Re: Plunkett Kuhr SFD – Plan Review Comments (First Review)
WC³ Project #: 217-525-188

We have reviewed the structural plan review comments listed above and dated October 26, 2017. See below for responses in bold italic font to your comments. The numbering of the responses corresponds to the numbering of the review comments.

Review Question: S9

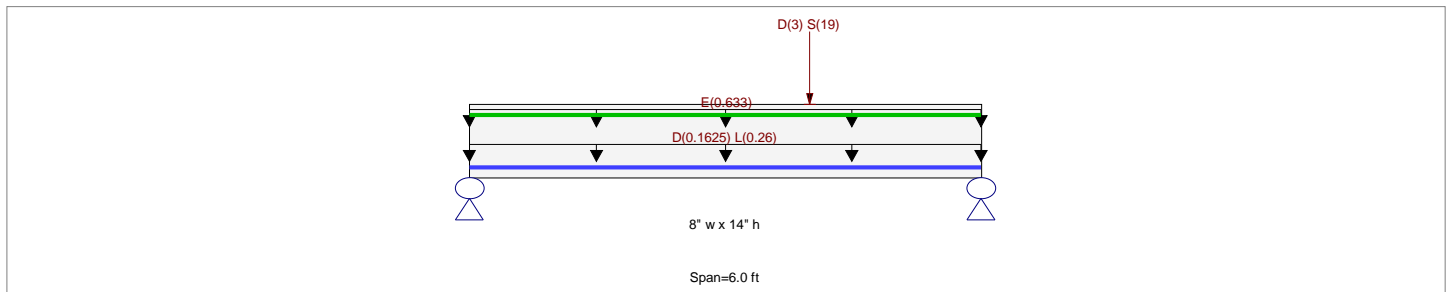
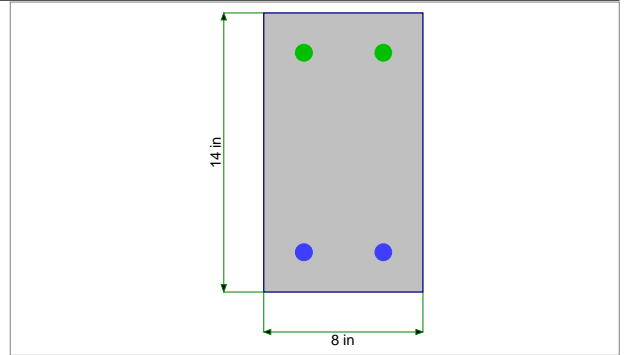
S9. The concrete lintel calculations show 16 inches deep by 10 inches wide. Detail S/S-300 shows 12 inches deep and the width could not be found. Please address.

Calculation and detail revisited. See revised plans and calcs for change.

Project description: Steel column tensile load check (worst case, location B) where in place of typ. holdown
 Location:
 Fastening description:

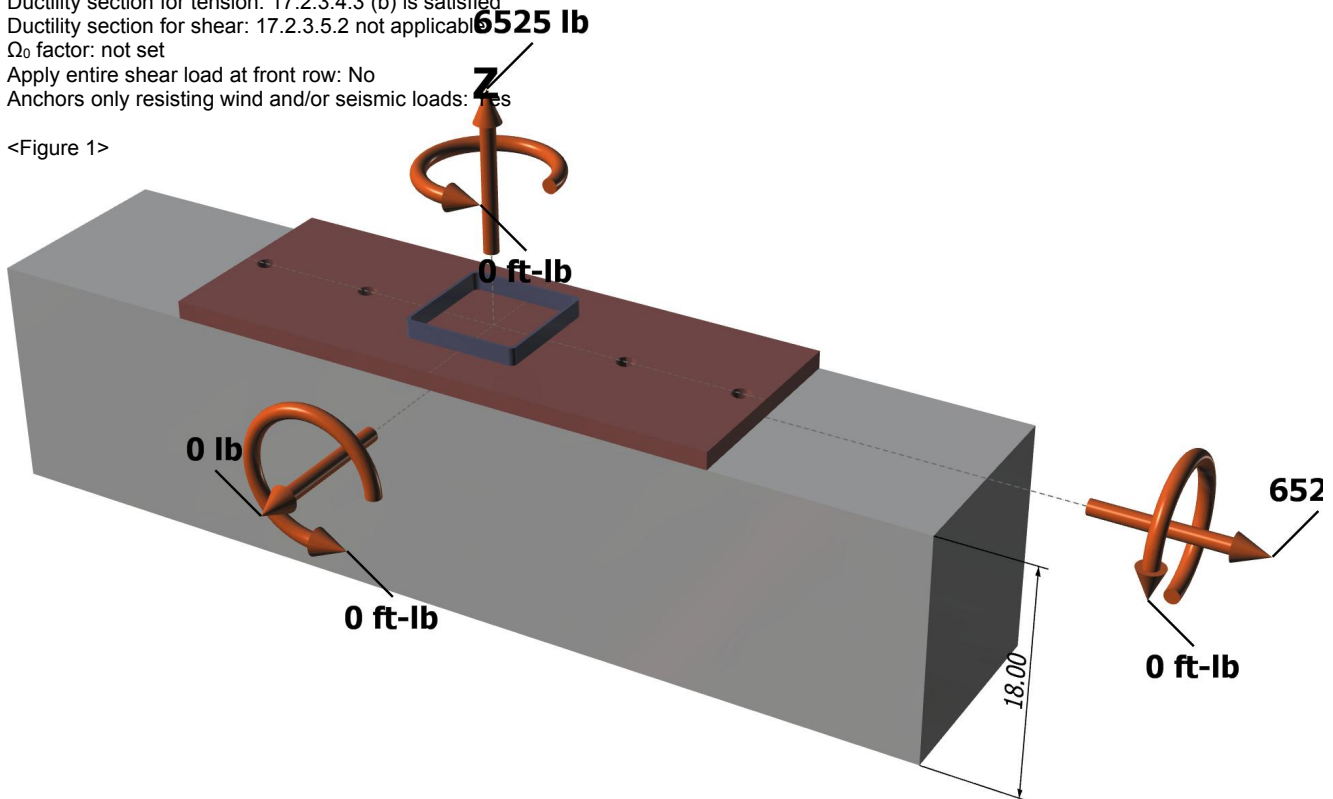
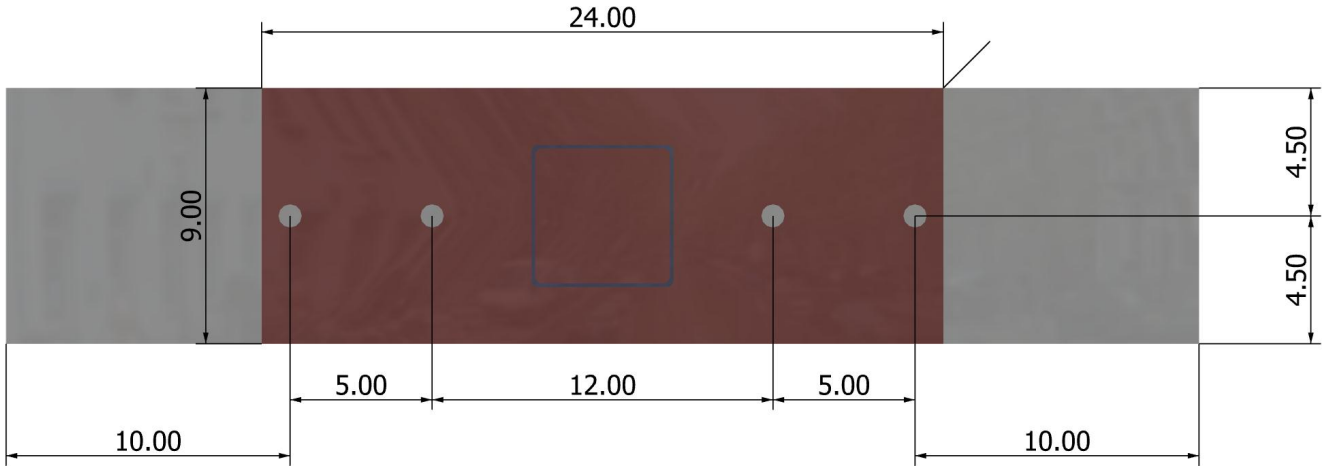
S11. Simpson anchorage calculations were done per ACI 318-11. Please verify that ACI 318-14 requirements have been met.

ACI 318-14 have been met. Updated calculation attached for reference. Please note, some holdowns have been eliminated in the locations where a steel column occurs. The typical steel column connection has been checked for max uplift and has been added to the supplemental calculation set for reference.

DRIFT LOADS

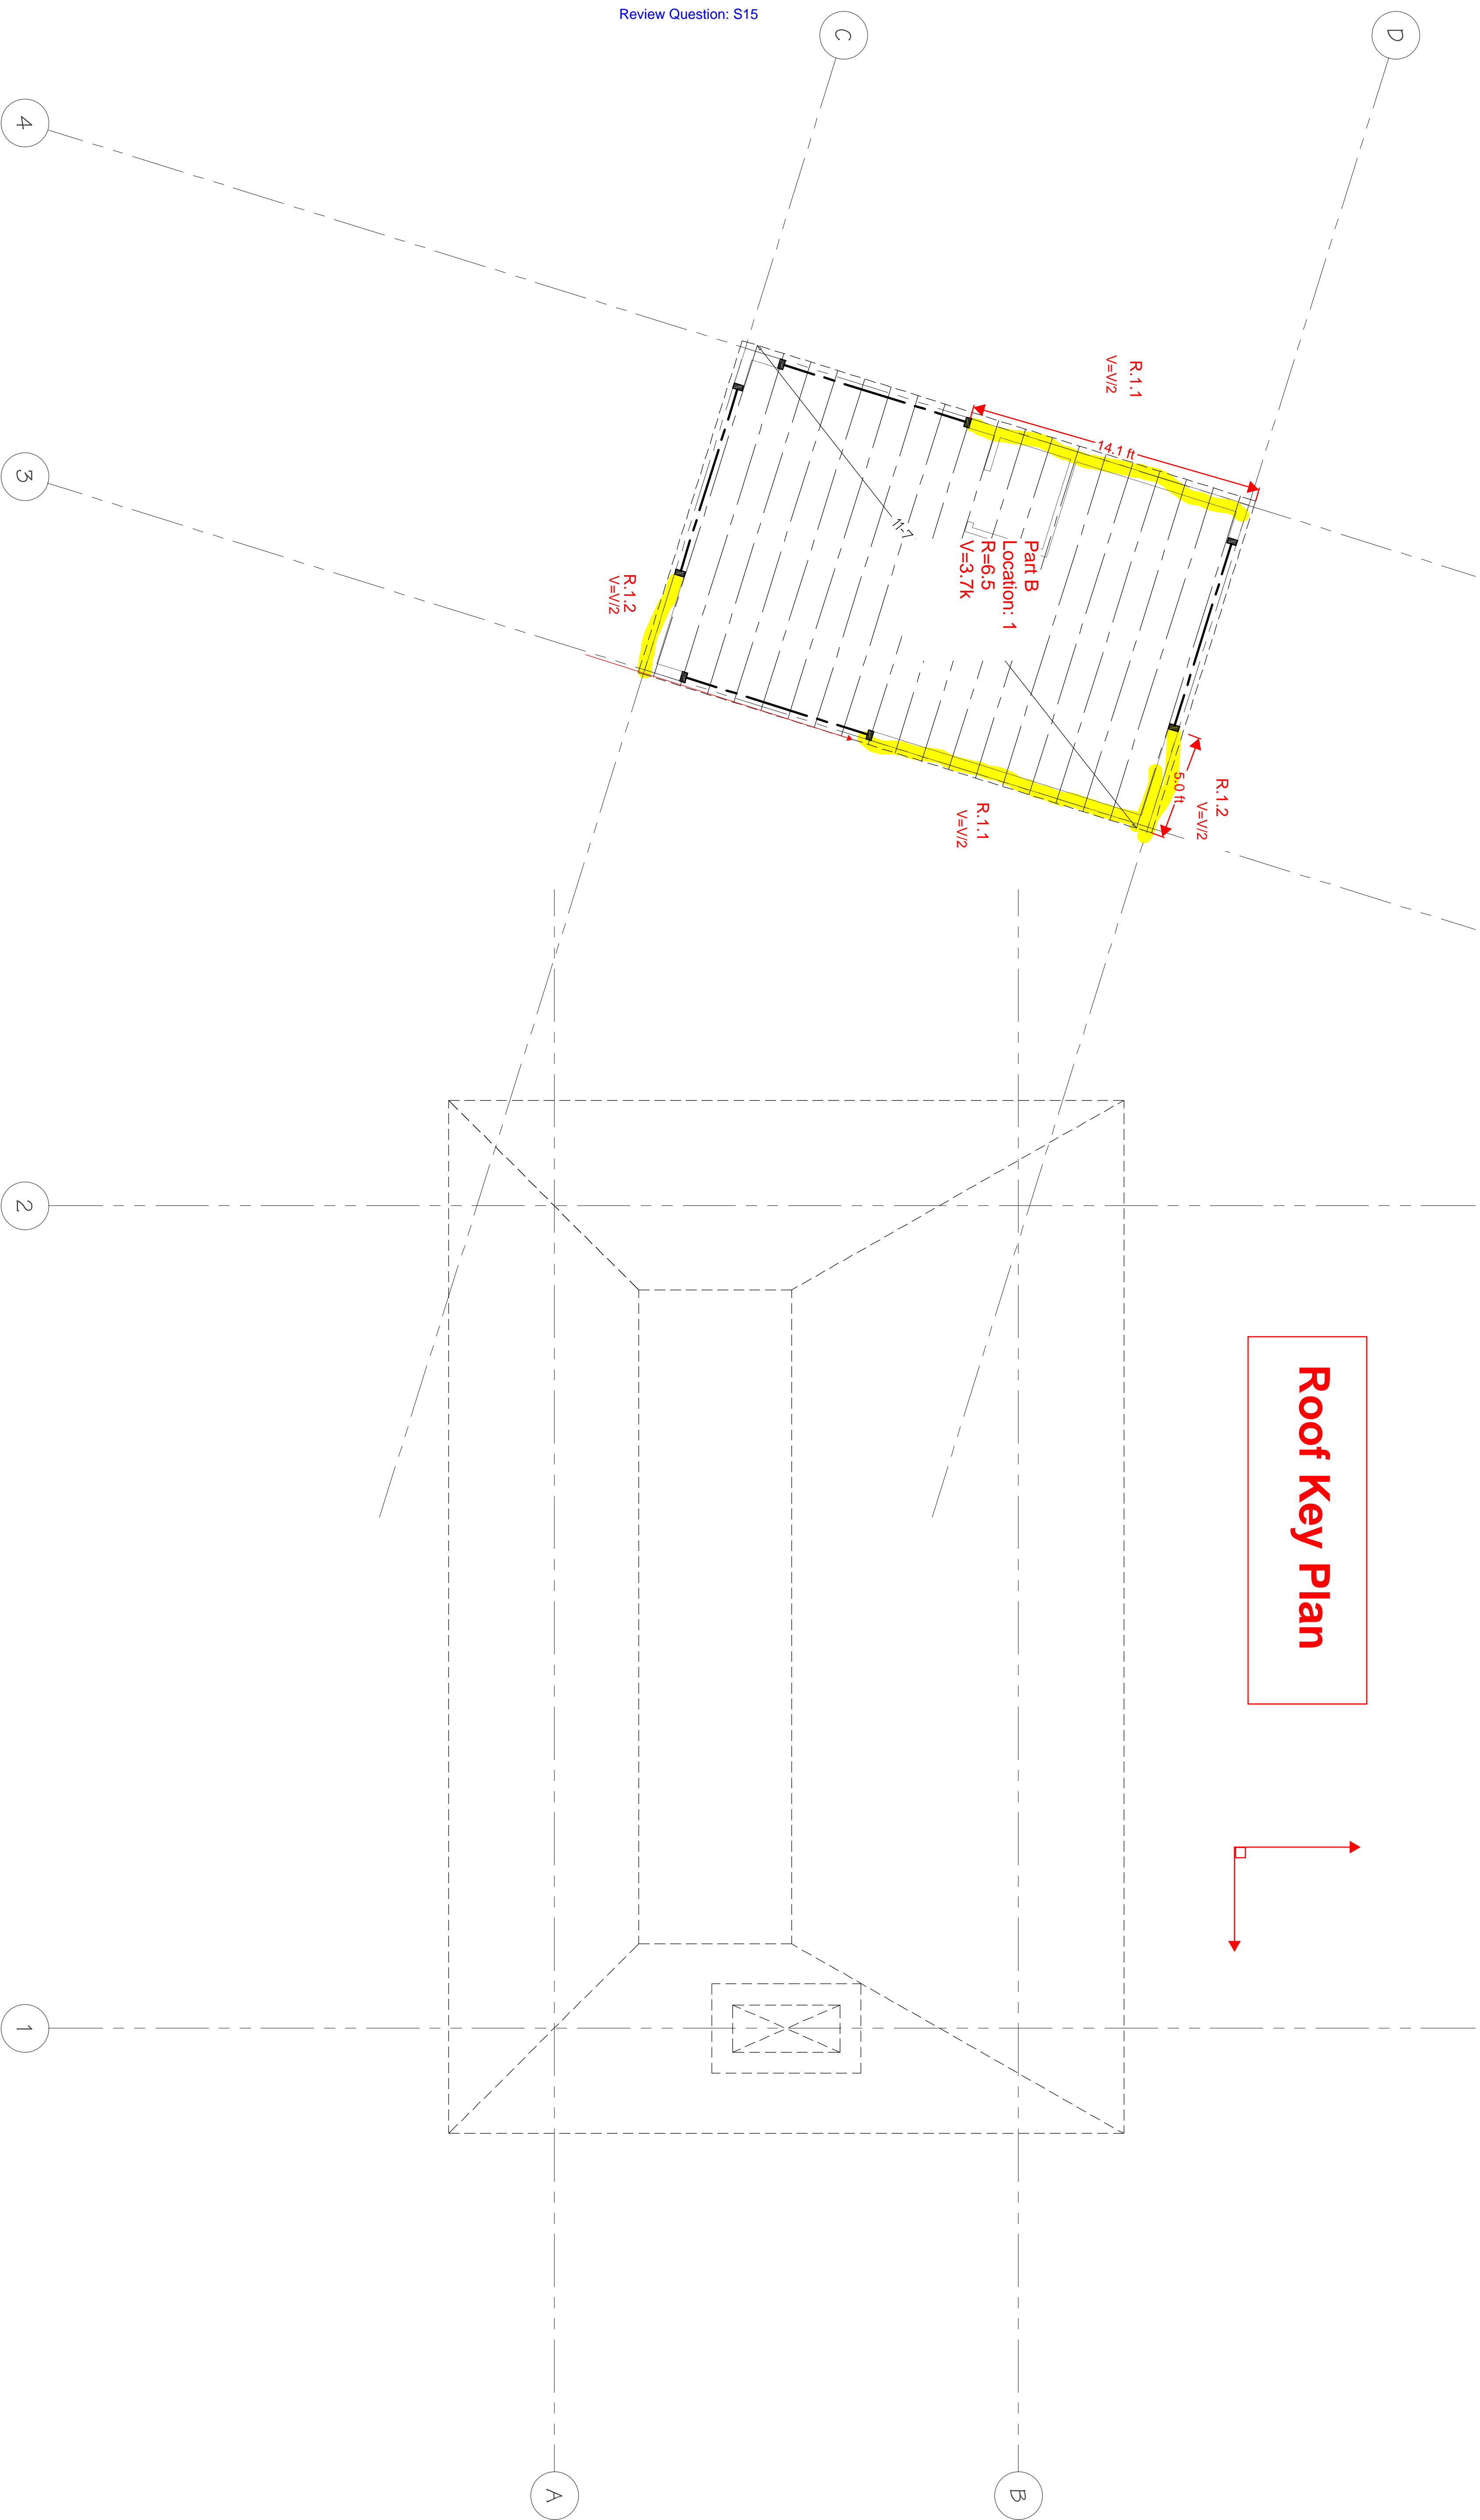
S12. Snow drift calculations could not be found and drift loads do not appear to be indicated on the plans. Please address.

The rooftop terrace, where drift is applicable, was designed for a live load of 252 psf. Max snow drift is 245 psf. See supplemental calculation for drift calc reference. The balcony that wraps around Part A does not include drift as its surface is covered by the eave.

Roof Key Plan

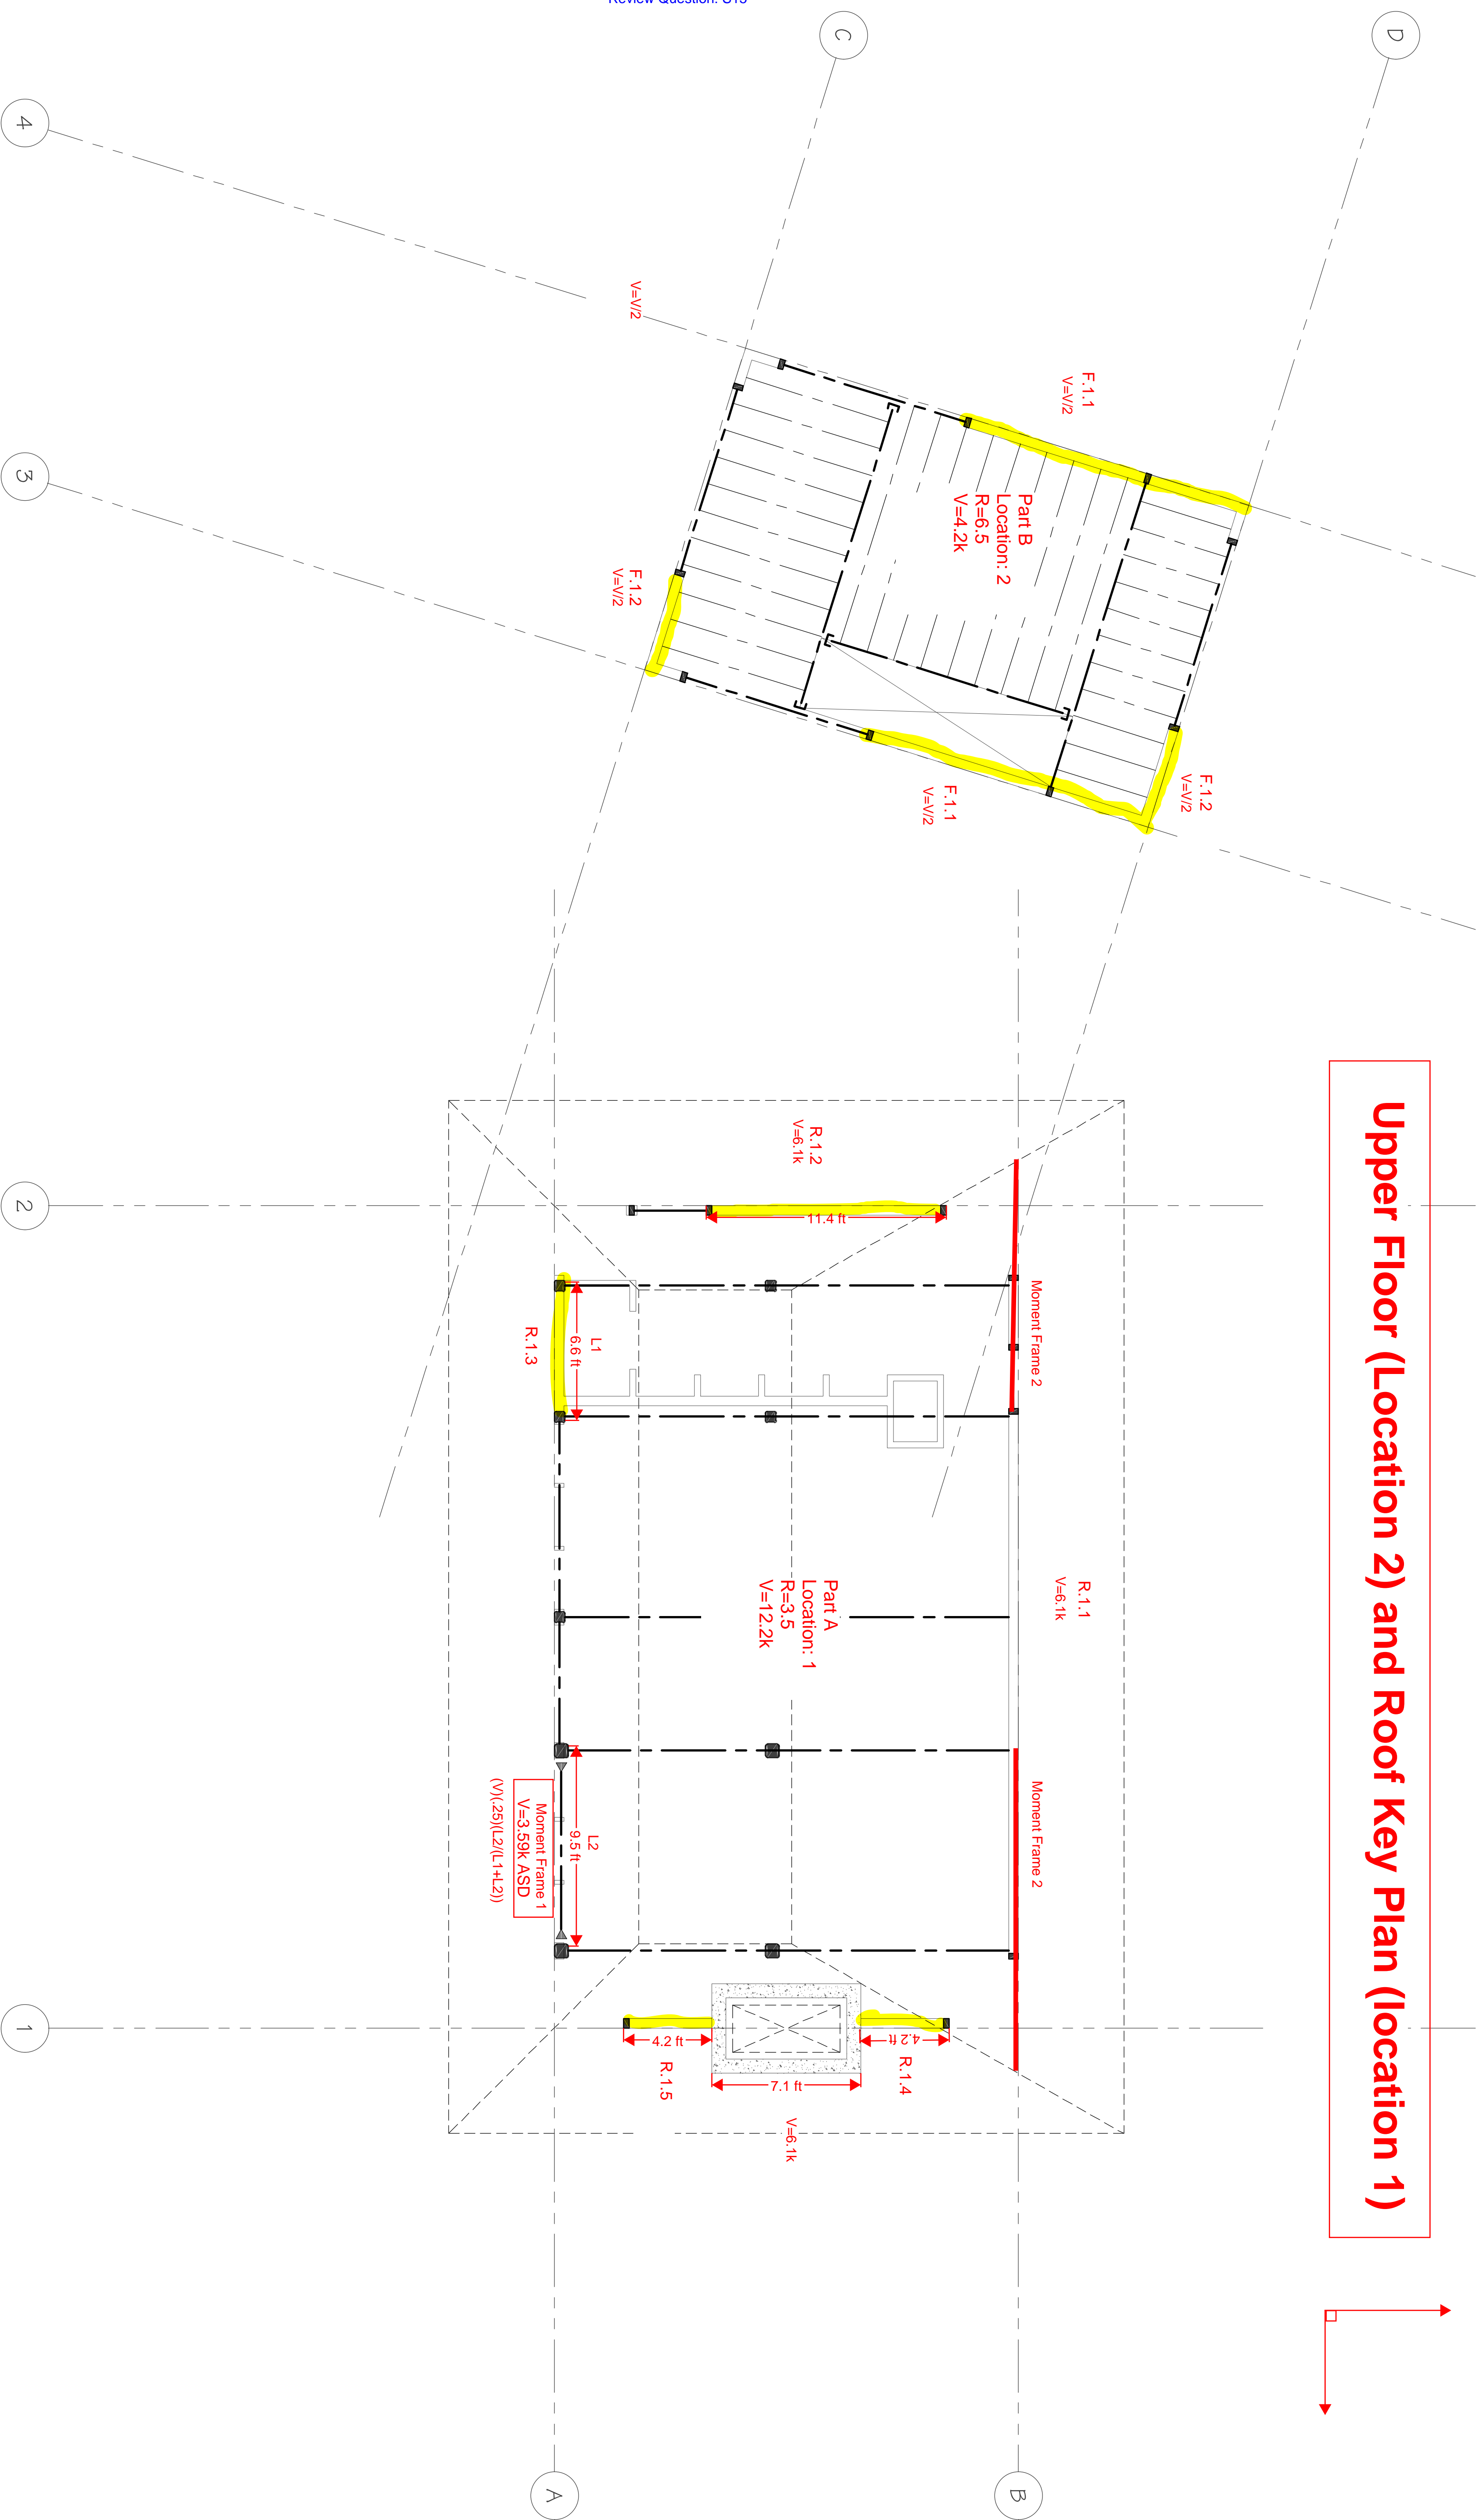
S15. The lateral design was difficult to follow. Please provide a key plan indicating all lateral resisting elements (i.e. shear walls, moment frames, etc.) along with a horizontal distribution of lateral forces per Section 12.8.4 of ASCE 7-10 for the structure showing which walls/frames were considered in the design and the shear load to each wall/frame.

Key plans and horizontal distribution have been added to the supplemental calculations.
